## **Access Compliance Report Public Rights-of-Way** (Curb Ramps)

Intersection ID: 24109 Main Street: ARBOR POINTE DR Cross Street: PARK\_RD Location: W ADA ID: 7D7B68E86496 Ramp Type: PerpDiag Initial Pass/Fail: Fail **Overall Compliance: No Severity Score:** 12.5

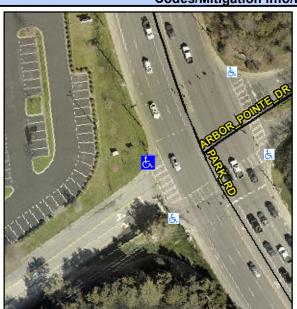
Field Measurements/Component Compliance						
	Compliance Description		Data	Compliance Description		Data
	N/A	Ramp Length (in)	60.0	No	Ramp Slope (%)	9.3
	Yes	Ramp Width (in)	48.0	Yes	Ramp XSlope (%)	2.0
	N/A	Flare Type LT	N/A	N/A	Flare Type RT	N/A
	N/A	Flare Slope LT (%)	N/A	N/A	Flare Slope RT (%)	N/A
	N/A	Flare Traversable LT?	N/A	N/A	Flare Traversable RT?	N/A
	N/A	Landing Length (in)	N/A	N/A	DWS Provided?	N/A
	N/A	Landing Width (in)	N/A	N/A	DWS Contrast?	N/A
	N/A	Landing Slope (%)	N/A	N/A	DWS Length (in)	N/A
	N/A	Landing X Slope (%)	N/A	N/A	DWS Full Width?	N/A
	N/A	Landing Curb? (Y/N)	N/A	N/A	DWS Offset (in)	N/A
	N/A	Shared Landing?	N/A			
	N/A	Gutter Ponding?	N/A	N/A	Gutter Slope (%)	N/A
	N/A	Gutter Lip Ht (in)	N/A	N/A	Gutter X Slope (%)	N/A
	N/A	Painted X Walk1?	Yes	N/A	Painted X Walk2?	No
		X Walk 1 Direction	To SE		X Walk 2 Direction	To NE
	N/A	X Walk 1 Width (in)	171.0	N/A	X Walk 2 Width (in)	N/A
		X Walk 1 Slope (%)	0.0		X Walk 2 Slope (%)	0.4

X Walk 1 X Slope (%)	0.1		X Walk 2 X Slope (%)	0.5
	N/A	Ramp inside XWalk1?	Yes	N/A	Ramp inside XWalk2?	N/A
		Road Slope (%)	0.0	N/A	Clear Space?	N/A
		Road X Slope (%)	4.7	N/A	Clear Space to XWalk (in)	N/A
	N/A	Any Obstructions?	N/A	N/A	Storm Grate/Utility Hazard?	N/A
		Obstruction Type			Storm Grate/Utility Type	
			N/A			N/A
				Yes	Surface Condition? (G/P)	Good
		Action to the second

Possible Solutions: Remove & Replace Curb Ramp With Two New Directional Ramps or Equivalent. Surveyor Notes: N/A PROW/ADA: R304.2.2
